***Interactive comment on* “Simulation of high mountainous discharge: how much information do we need?” by B. Schaefli and M. Huss**

Response to Reviewer 3

Fig. 1.

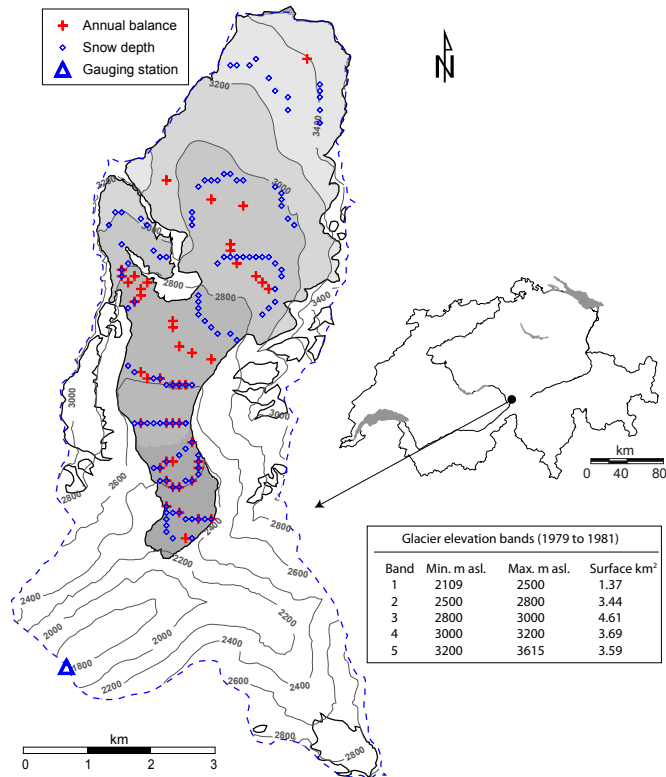
1)- 3) *Clearer introduction and map*

We will include a map (see Fig. 1 hereafter) showing the topography and include some information on the range of elevation of the catchment (the outlet is at 1760 m asl, the glacier ranges from 2109 to 3615 m asl). The used elevation bands for the glacier are given as inset in fig. 1 of this comment.

Fig. 2.

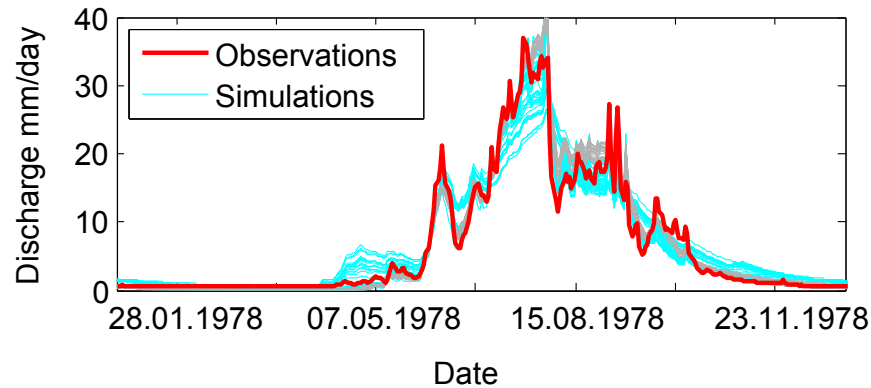
10) *Comment: p.8680 line 11 I cannot see that ' there is still too much discharge in spring (..)*

Something went wrong during the production process, we uploaded a figure with two different panels, one of them showing discharge simulations; the correct figure is added hereafter (fig. 2).

Fig. 3.

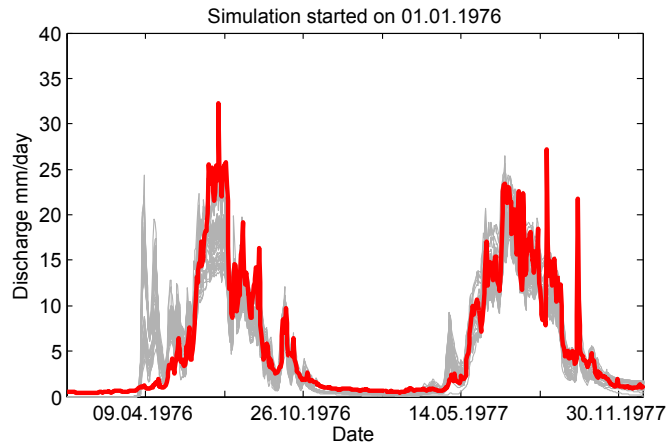
13 b) Comment: If I count days correctly (please use date on axis) this over estimated 'spring event' was as early as March or beginning of April in 1977 (...). Could it also have to do with consequences from the extreme dry year 1976 (refill of depleted storage in talus, moraines, englacial drainage, pro-glacial lake, etc. after the dry year 1976)?

This pattern of overestimation is recurrent at the beginning of the simulation period, independent of the starting year (see fig. 3 hereafter that shows the same effect for a simulation that started 4 years later); this reflects the time the model needs to initialize its state variables. If there was a systematic overestimation of snow accumulation during winter or of snowmelt in spring (e.g. due to the simple degree-day method not considering slope and aspect), this overestimation would be visible in many simulation years and not grouped at the beginning of the simulation period.
